Date: May 13, 2019  
Contractor: Sorter Construction, Inc.  
Project: 2019 Monument Road Bicycle Path Trail IFB-4618-19-DH

Date: May 7, 2019  
Company: Sorter Construction, Inc.  
Project: 2019 Monument Road Bicycle Path Trail IFB-4618-19-DH

3. Q. The railing system for the approach rails shown on sheet 98 (B-8) appear to differ from the railing system for the bridge shown on sheet 99 (B-9). Please confirm if the railing system for the approach rails needs to match the bridge?

MONUMENT ROAD BICYCLE PATH  
STORM WATER MANAGEMENT PLAN

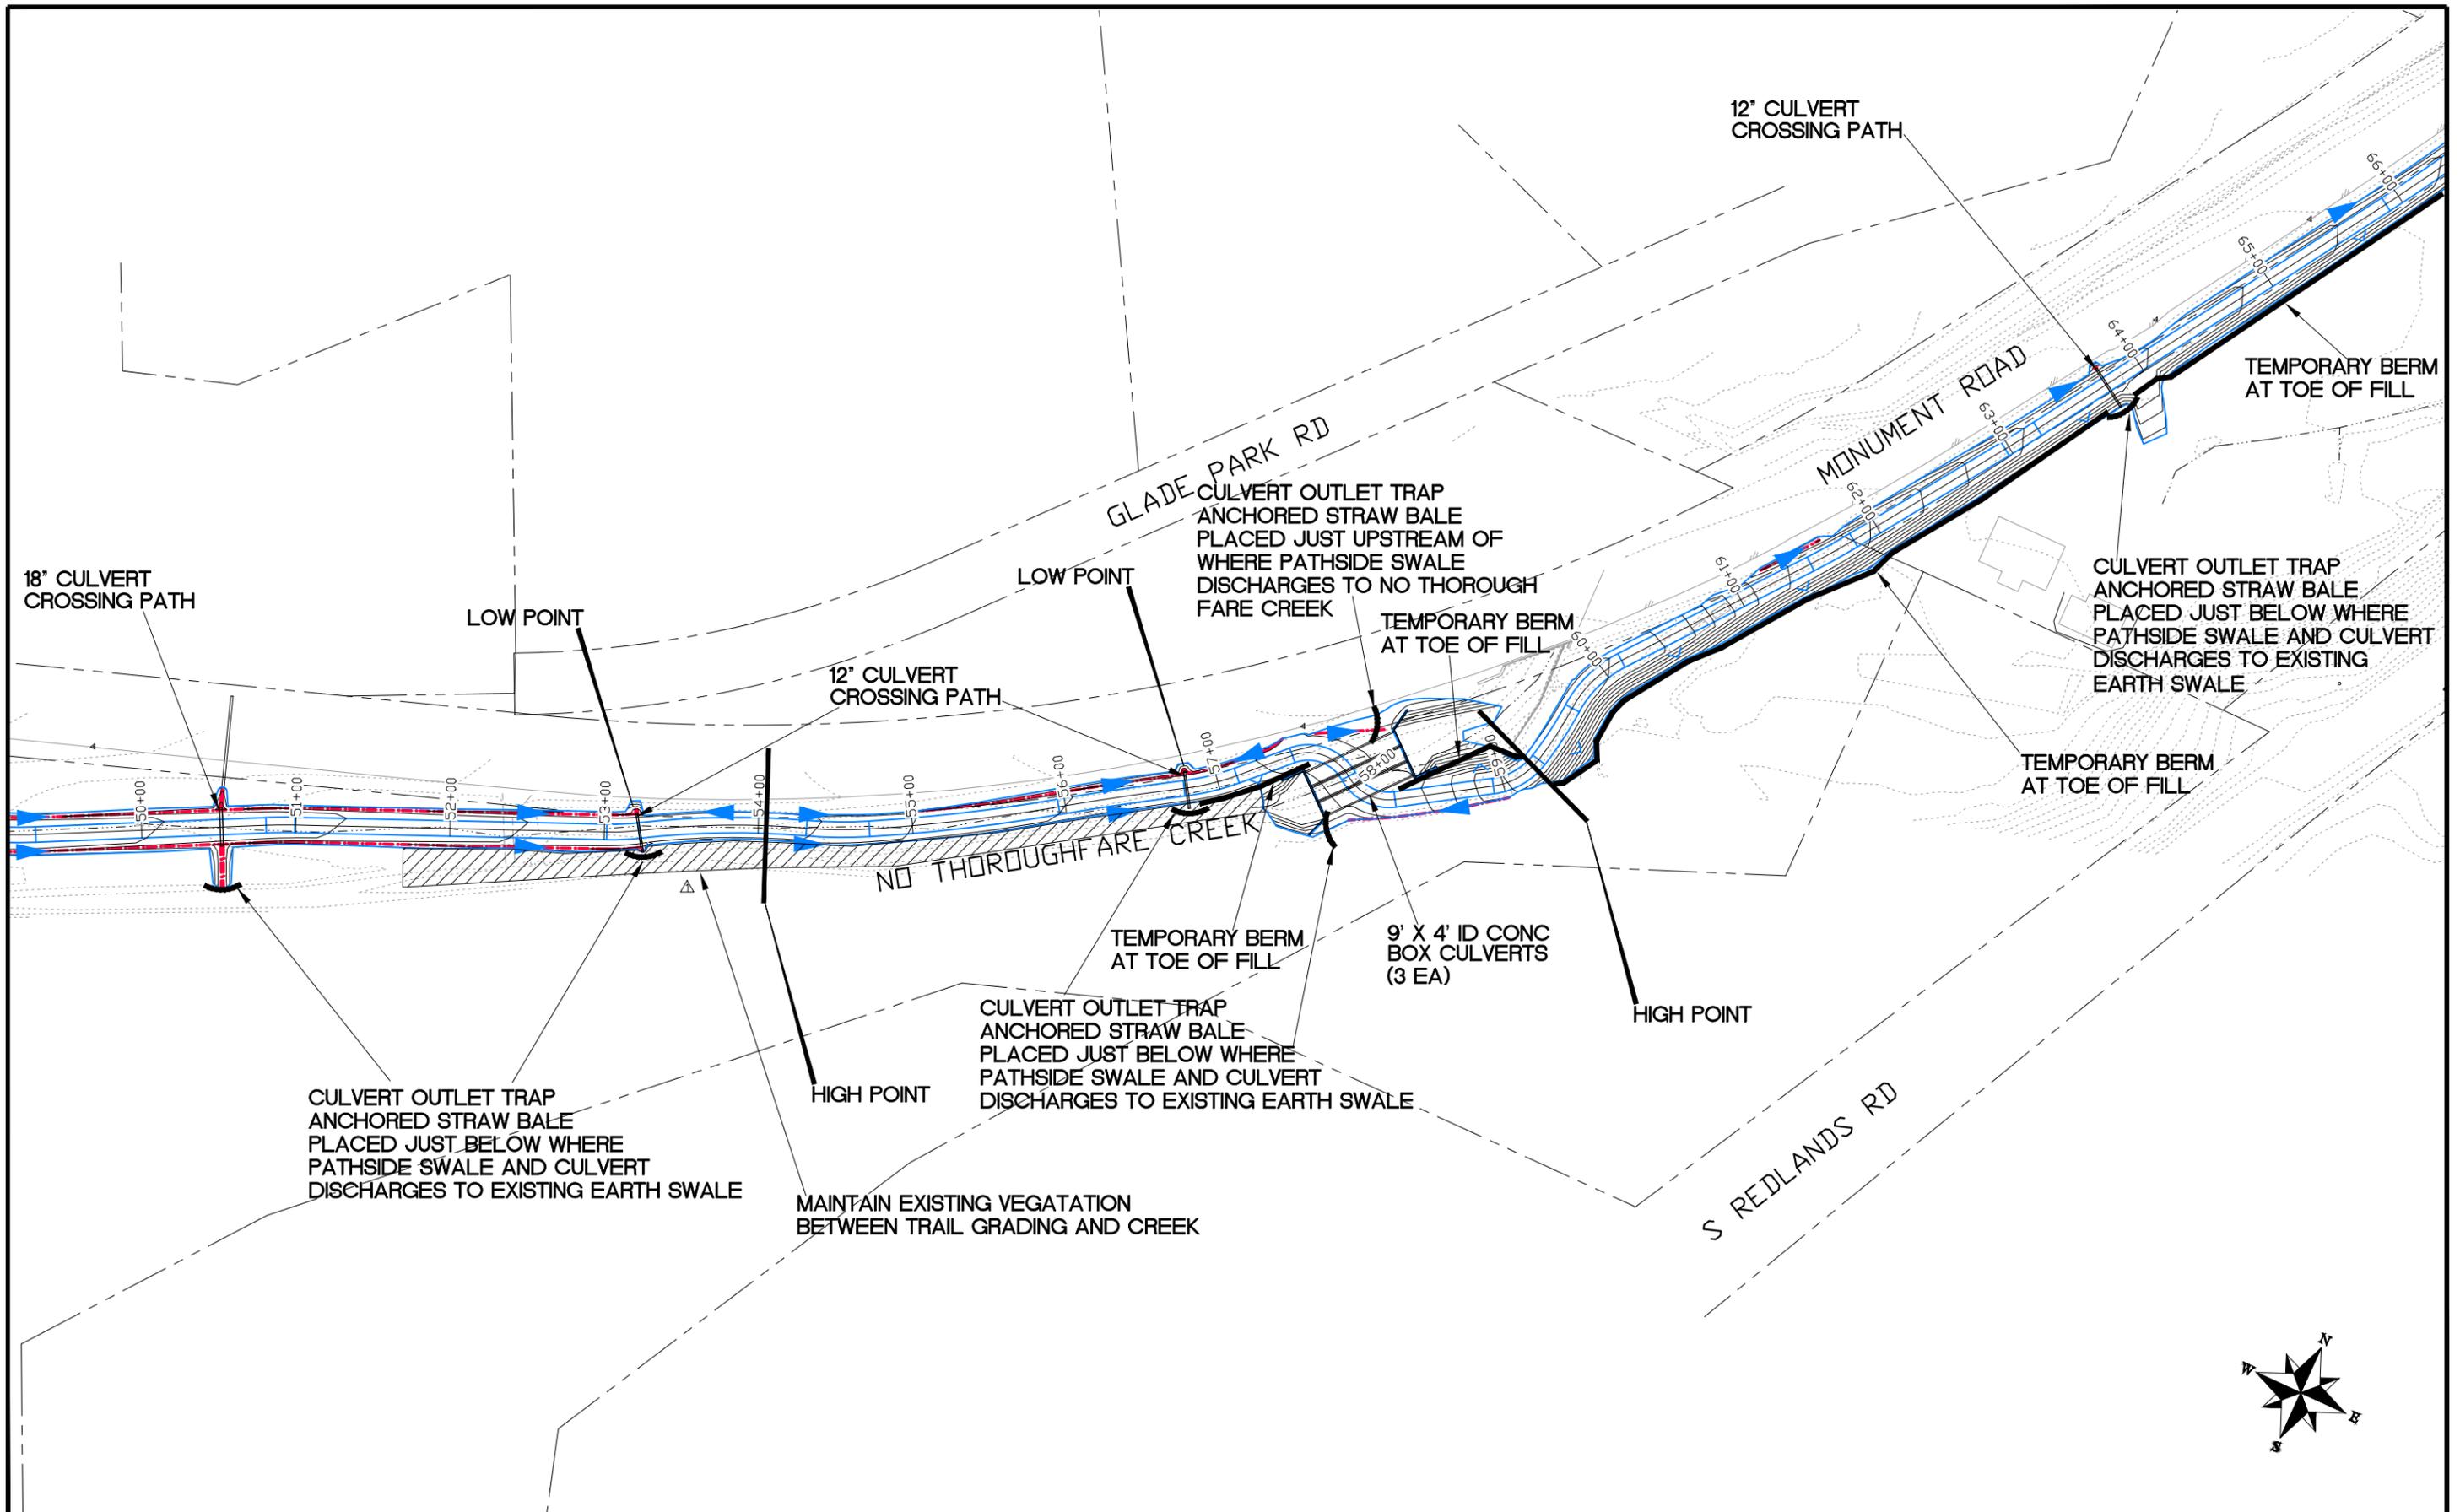
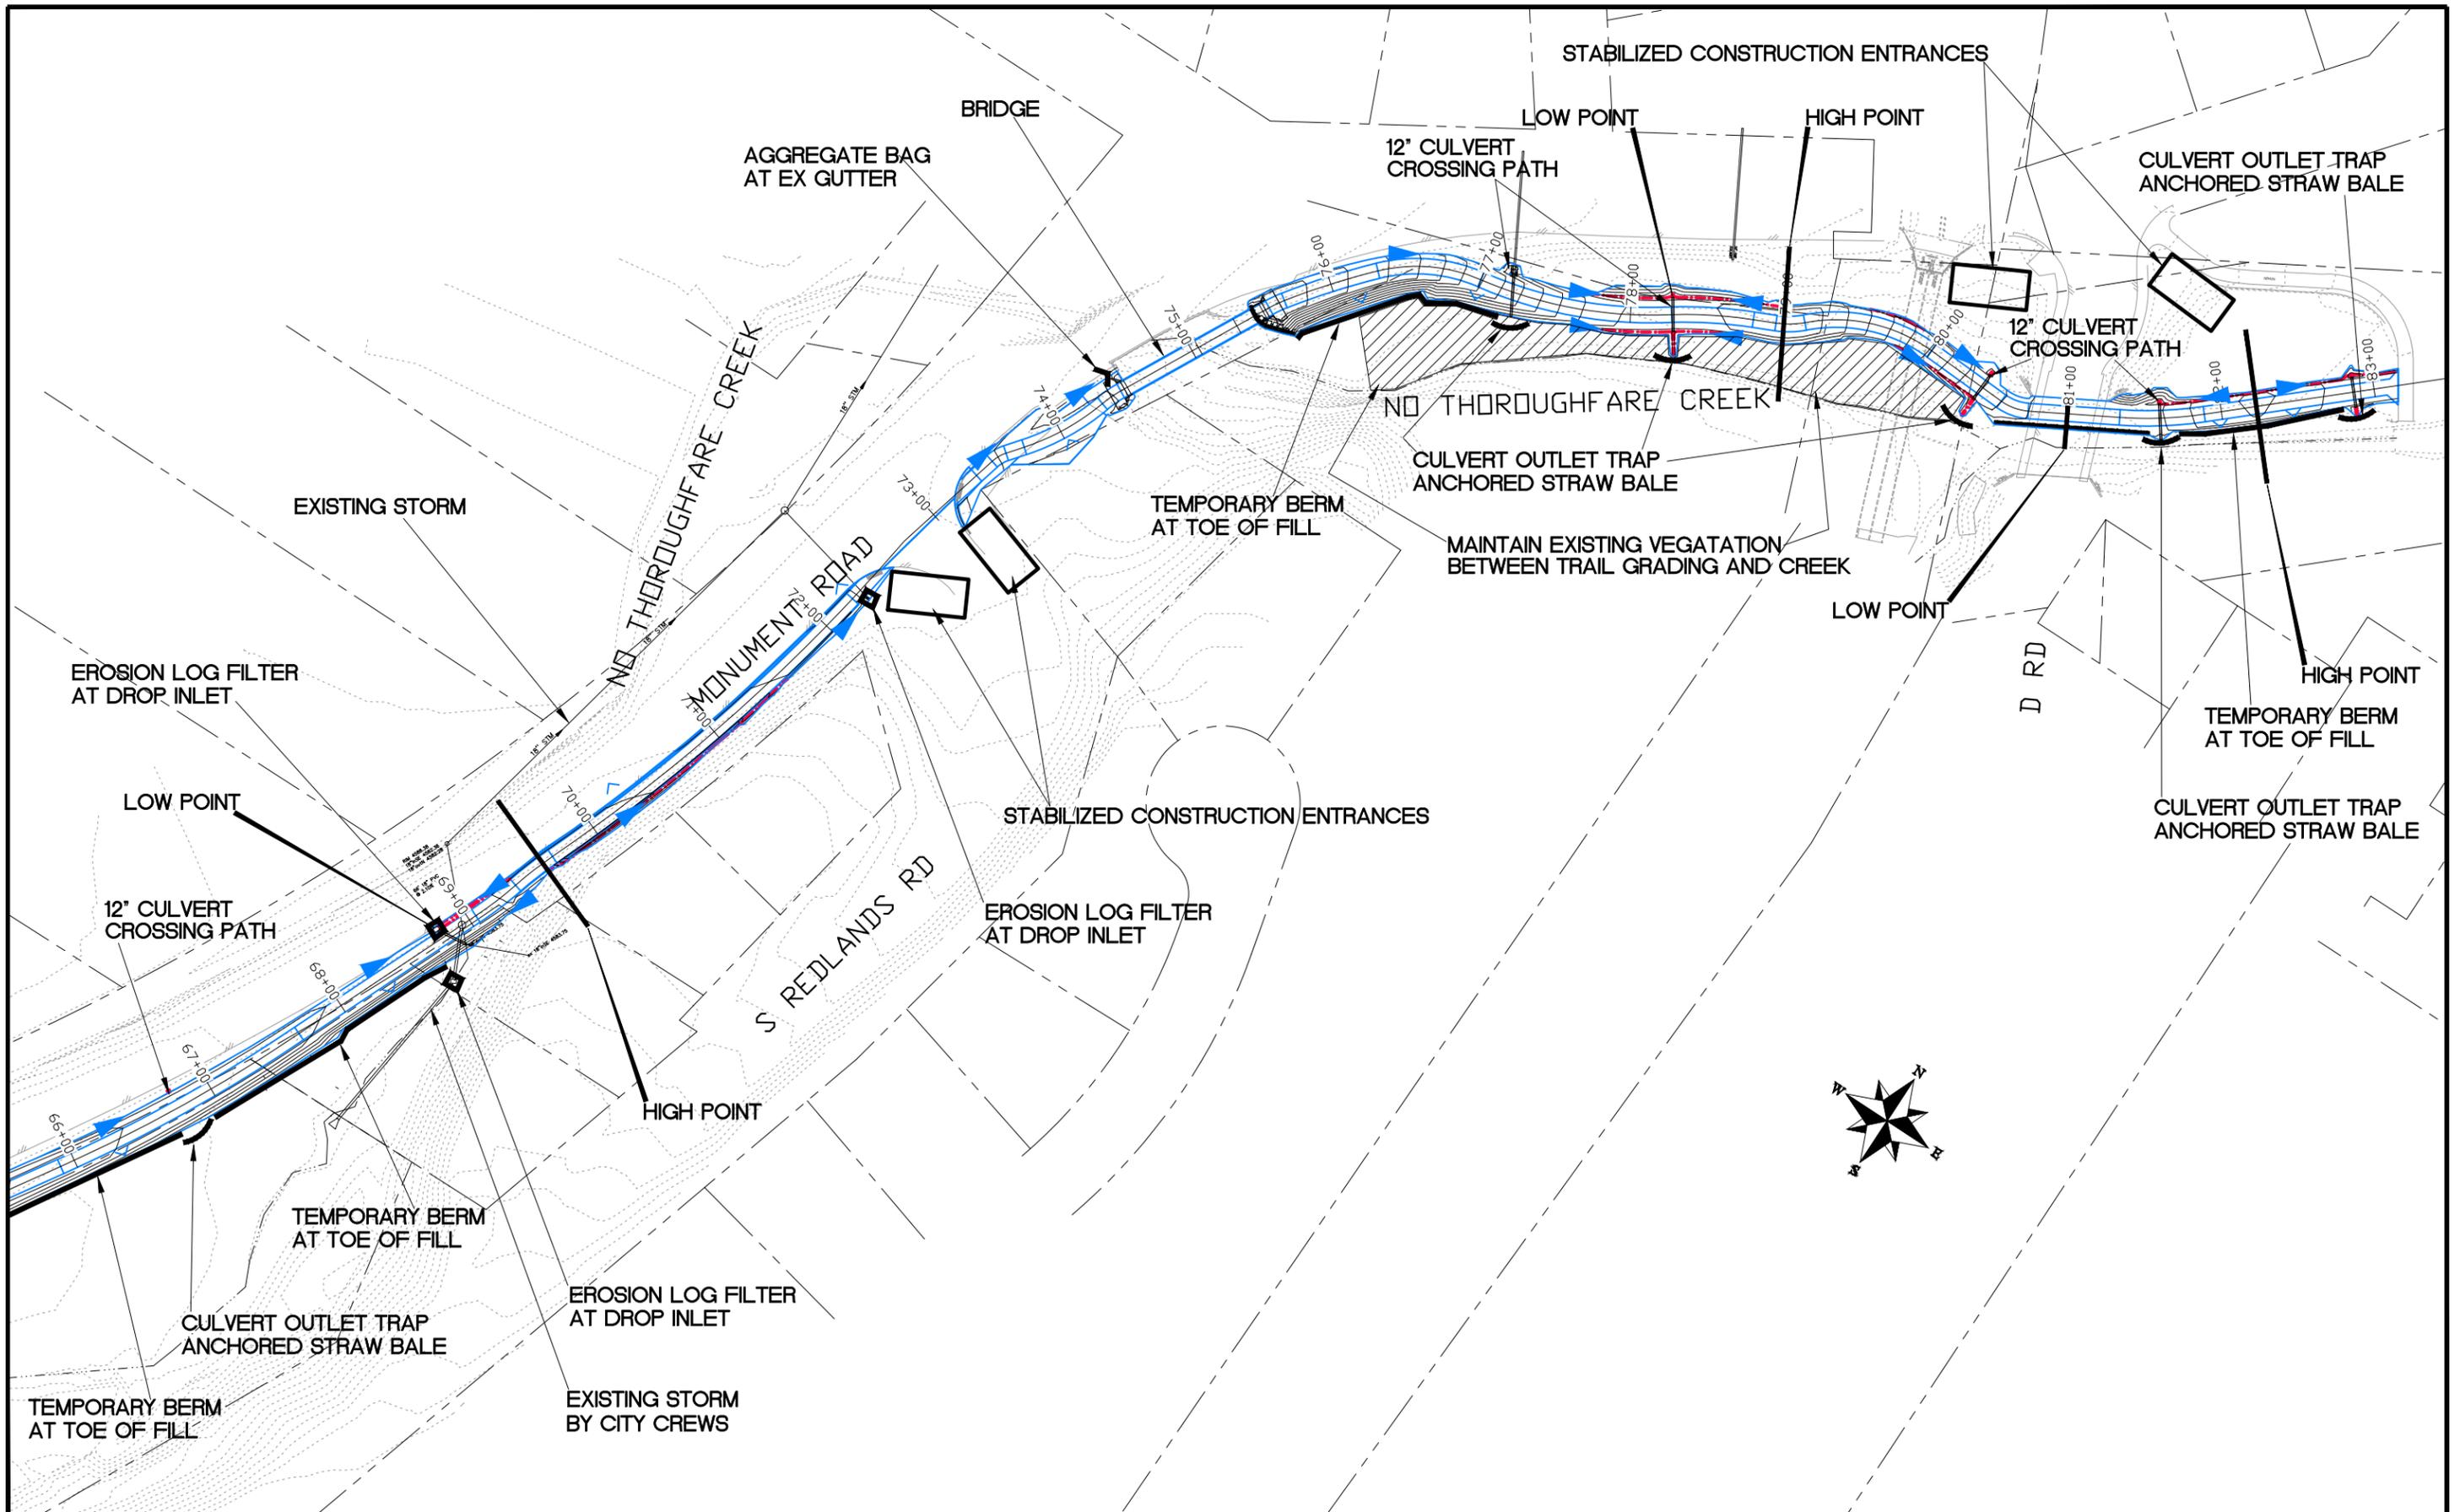
1. Q. See attached updated drawing sheets 12, 13 and 15 for the wall design, as well as sheets 89 & 90 for the Stormwater Management Plan.

REVISION	DESCRIPTION	DATE
REVISION $\Delta$	MAINTAIN EXISTING VEGETATION BETWEEN TRAIL GRADING AND CREEK	3/26/19
REVISION $\Delta$		
REVISION $\Delta$
